PUBLIC UTILITIES COMMISSION

RE: Valley South Subtransmission Project: Minor Project Change #3

Attachment A: Location of Proposed Additional Access and Work Areas

VSSP MPR 3 - Additional access roads and work areas

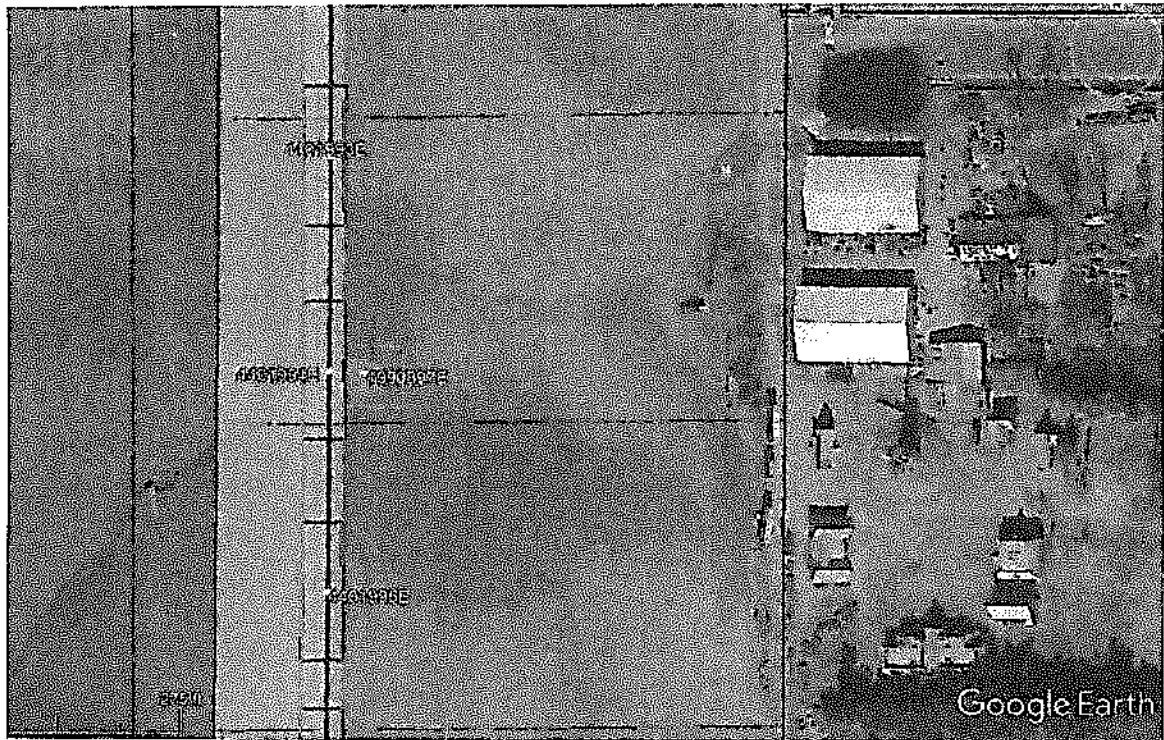
Add access road to 2091014E

Add access road to 4937058E

Add access road to 4439130E.

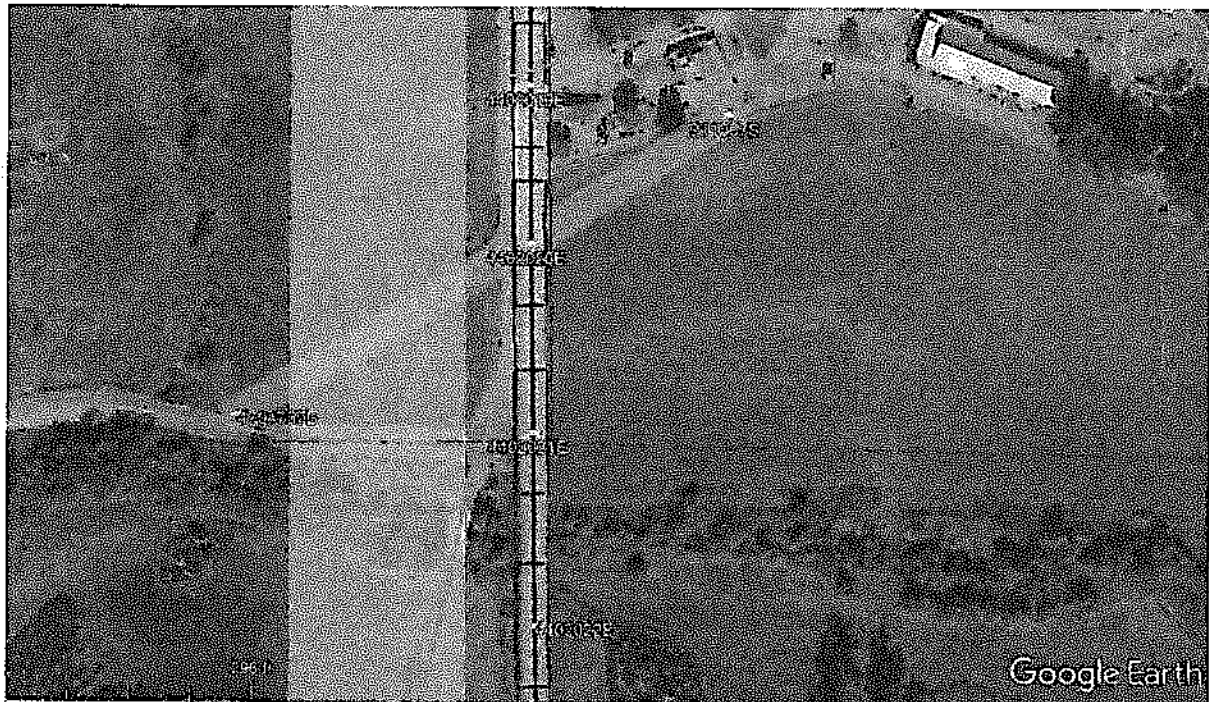
Add access road for 1623623E

Add work area for 1990897E

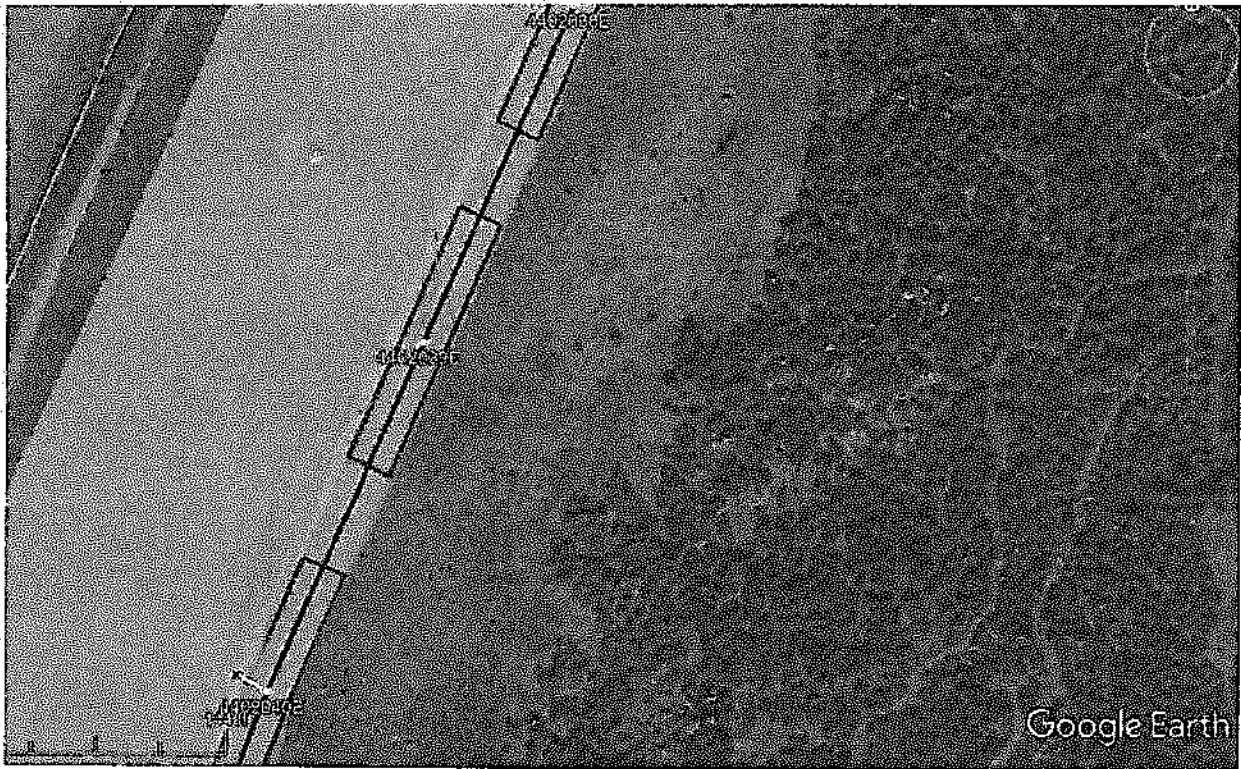
Add work area for 211257S

Add access road for 4402022E
